Approval Drawings

ICF general arrangements, steel over ICF, elevations, sections and the questions for the engineer

Icf Homes - Dendrons

ISSUED	24.09.26
SHEETS	15
DRAWN BY	BuildEase

FF STEEL OVER ICF

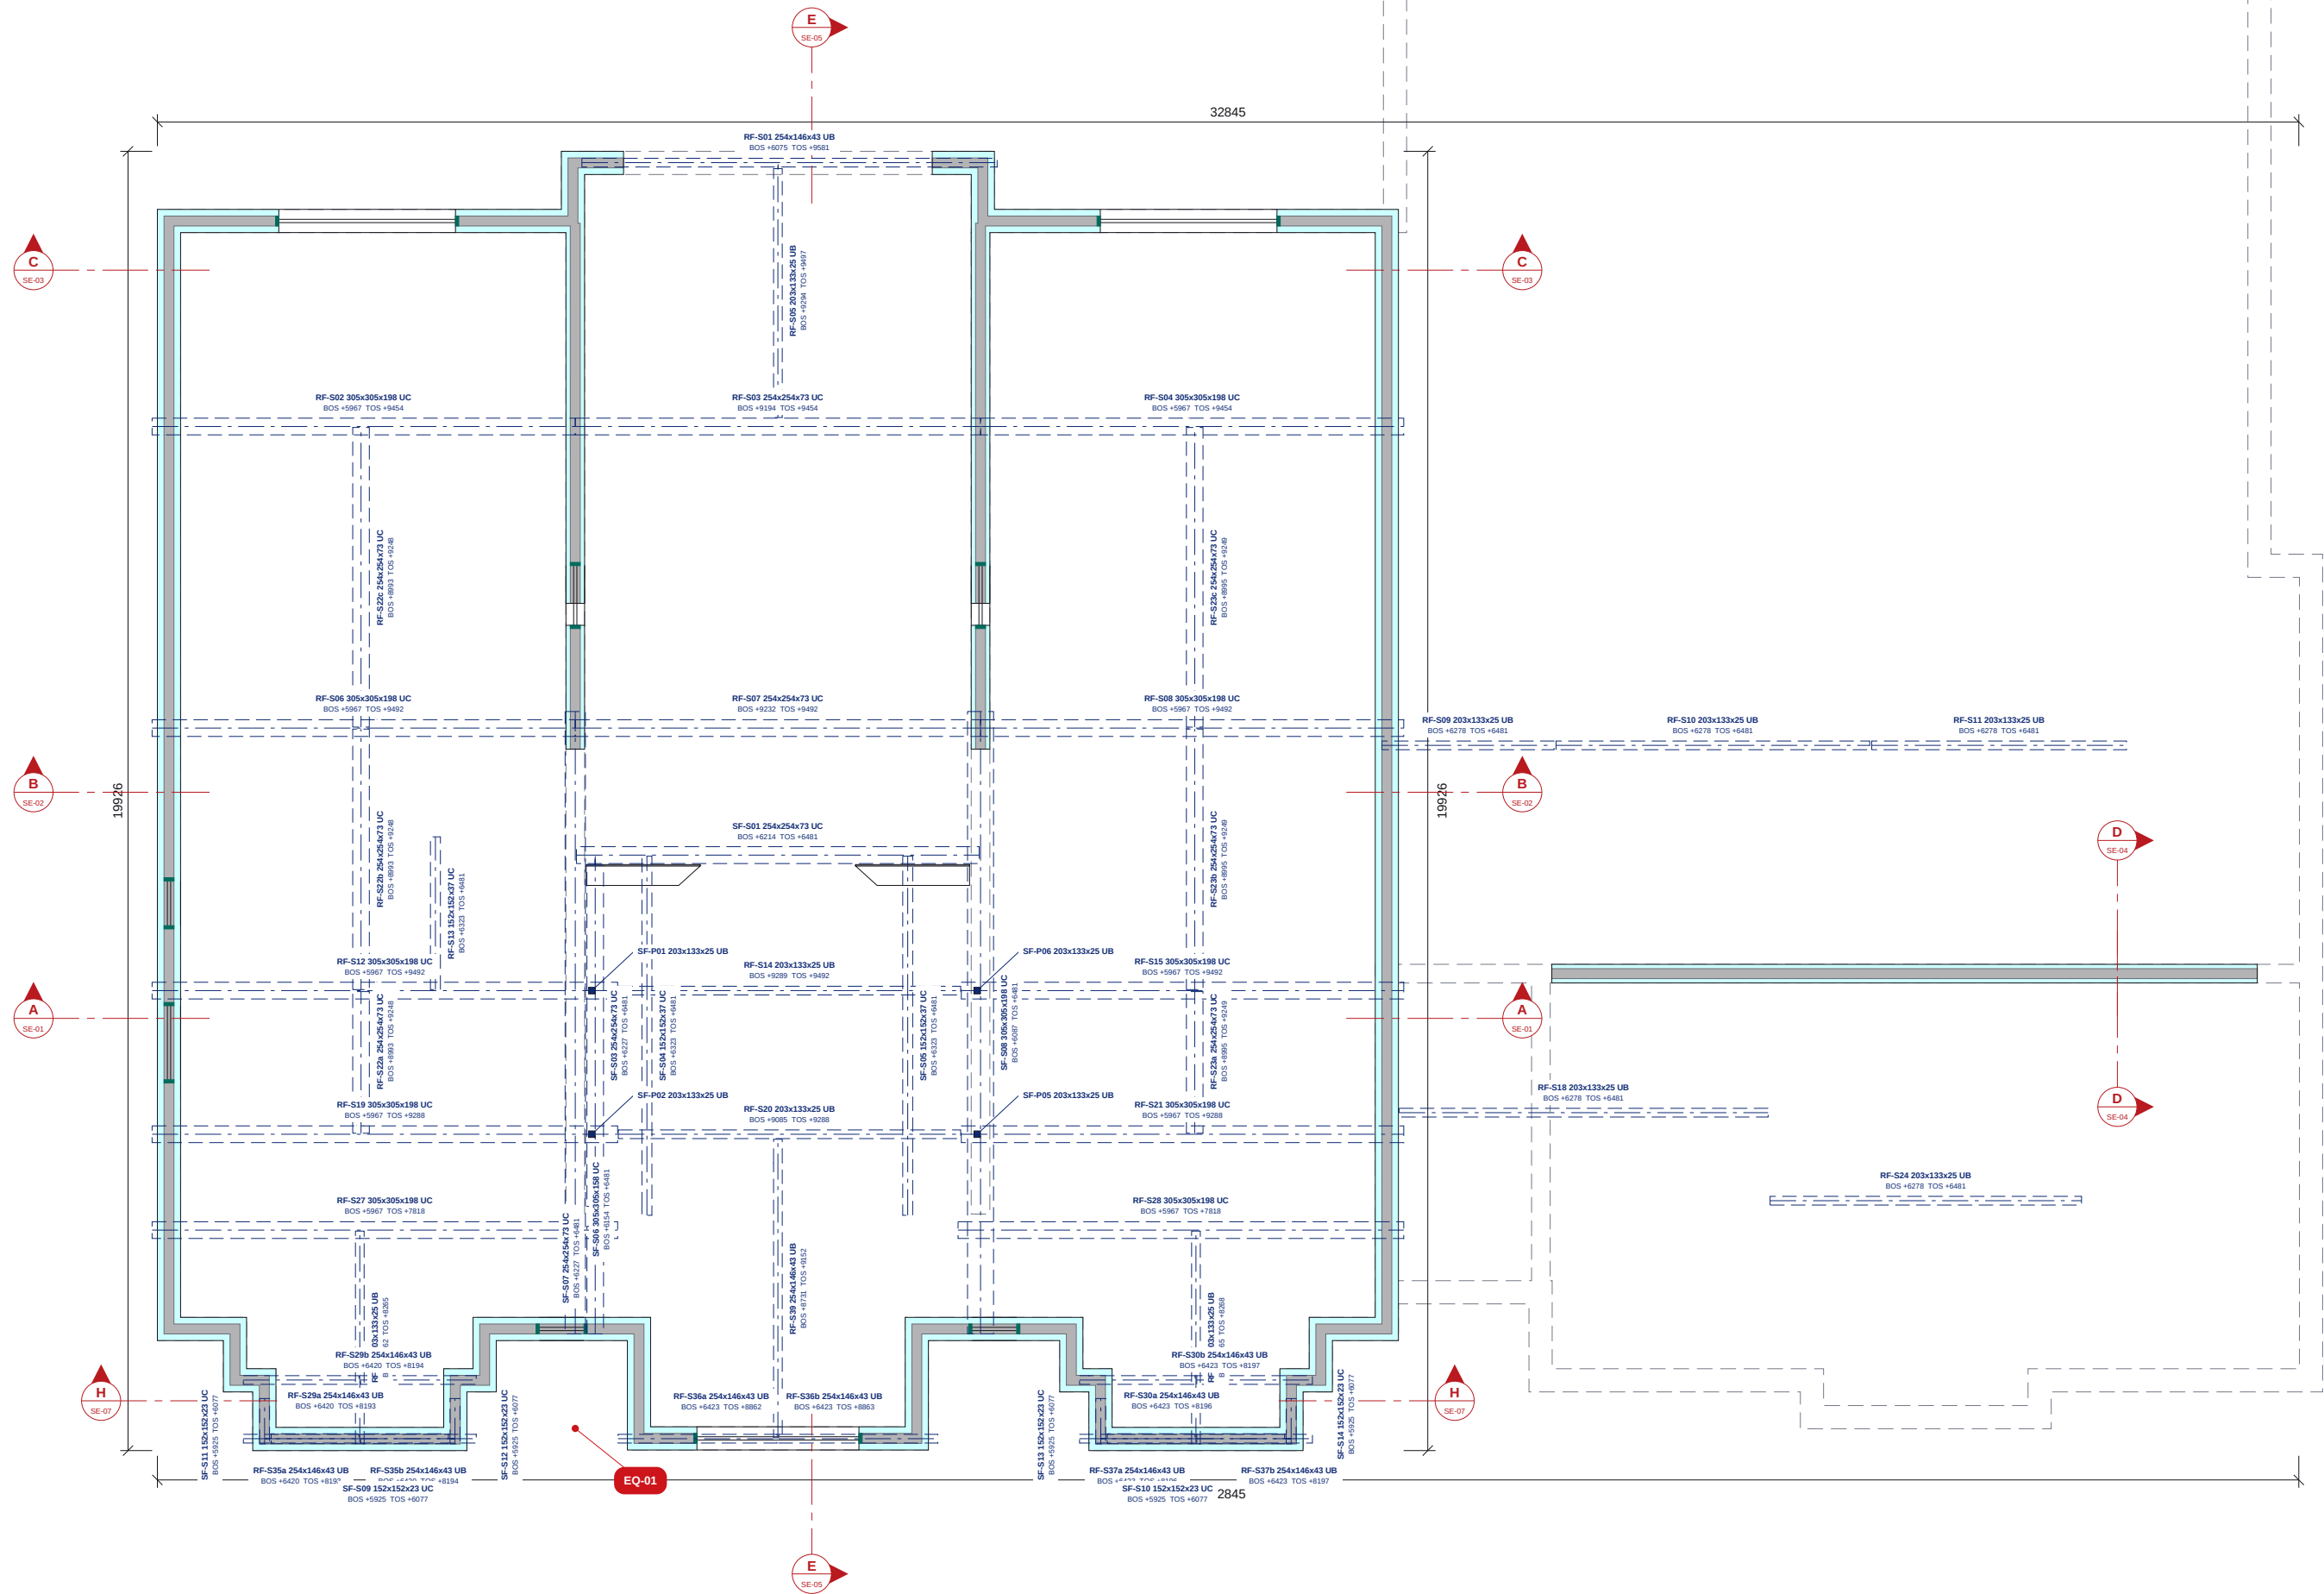
5. One question for the structural engineer (EQ-01: the SF-S06 / SF-S08 bearings over the FF windows FF-WF02 / FF-WF19) is open on sheet UKPCS-003-EQ-01; the red EQ tag on the FF steel sheet links to it.

ICF model (GS-02)

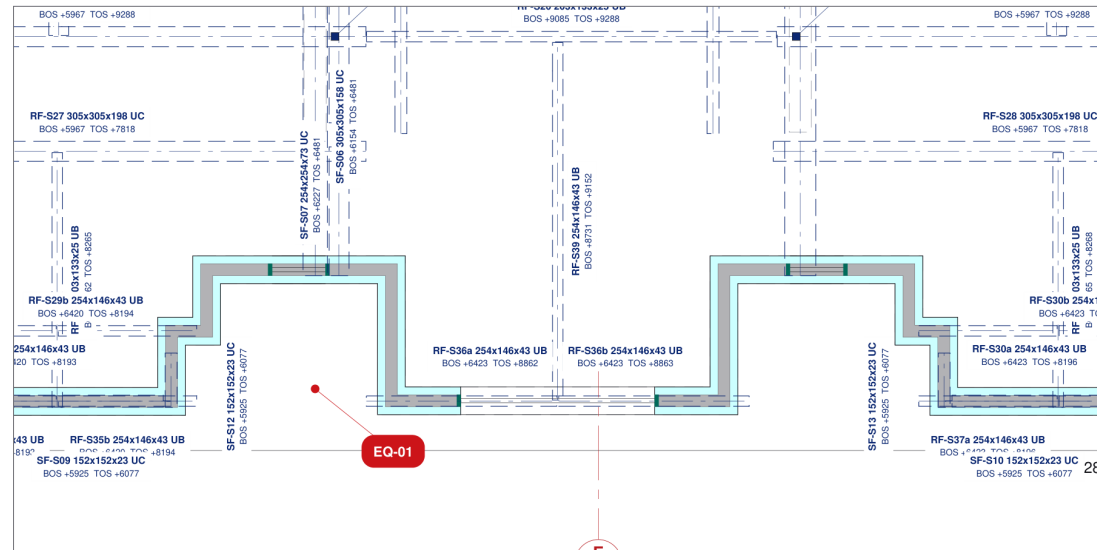
The second-floor transfer beams SF-S06 (UC 305x305x158, x 6370) and SF-S08 (UC 356x406x287, x 12586) bear on the south wall (L2, top 174.975 AOD) directly over the 685-wide FF windows either side of the entrance bay. At TOS 175.229 the beam undersides are 6252 (S06) and 6185 (S08) above the slab datum; the architect's window head is 6023, leaving 229 mm (S06) and 162 mm (S08) of wall between head and beam. S-121 schedules an RCB152 x 300 - 2H16 intel there, which would reach 6323, 71 mm into SF-S06 and 138 mm into SF-S08.

Please confirm the bearing detail: a steel spreader under each beam end (model assumption UC 152x152x30, 1285 long, 300 bearing each side, TOS = beam underside), or a revised lintel / beam arrangement. The window positions are the architect's and are held.
